210 Series Pump Mounting Orientation on 4x4 Vehicles

Figure 1 – 210 Series PTO with PGP315 pump mounted bulge towards 10R140 Transmission

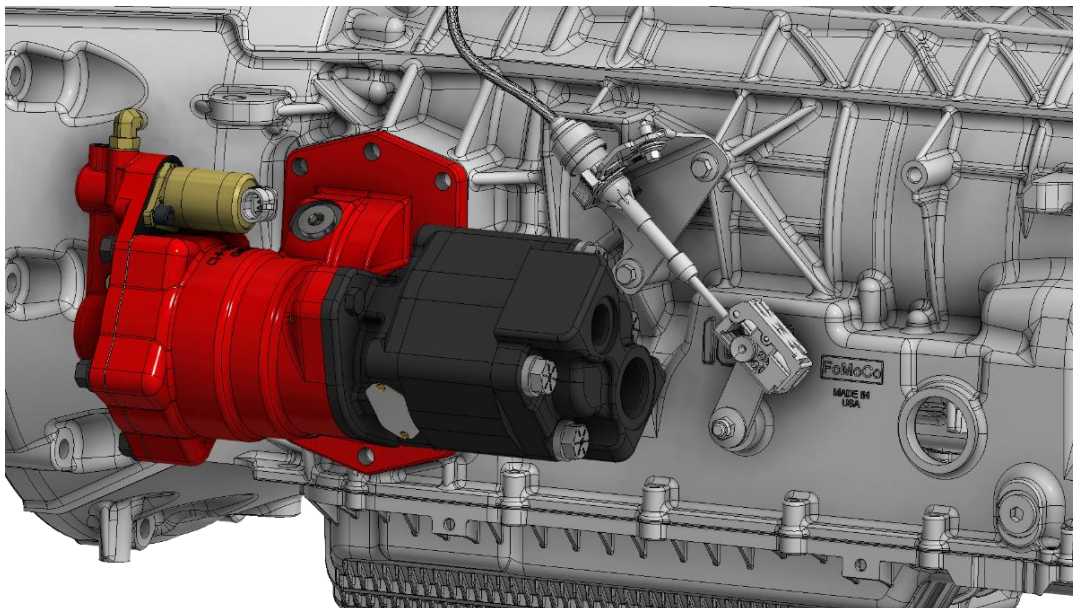
Due to the dynamic motion and potential loading of a 4x4 vehicle using the 10R140 transmissions, there is a possible interference between the pump and the driveshaft if the pump is mounted with the bulge out towards the driveshaft. Clearance between the pump and the 4x4 driveshaft is not as large as it may seem when the vehicle is stationary or on a lift. **Therefore, our engineering team stresses all 4x4 compatible pumps MUST be mounted with the bulge toward the transmission (See Figure 1).**

We will be updating our 210 Owner's Manual (HY25-1400-M1) highlighting this installation requirement. We have also added this as a note to the FRD-13 application page (which covers Ford 10R140 transmissions). This requirement is needed to ensure interferences do not occur with any other components shifter assemblies, hardlines, etc.
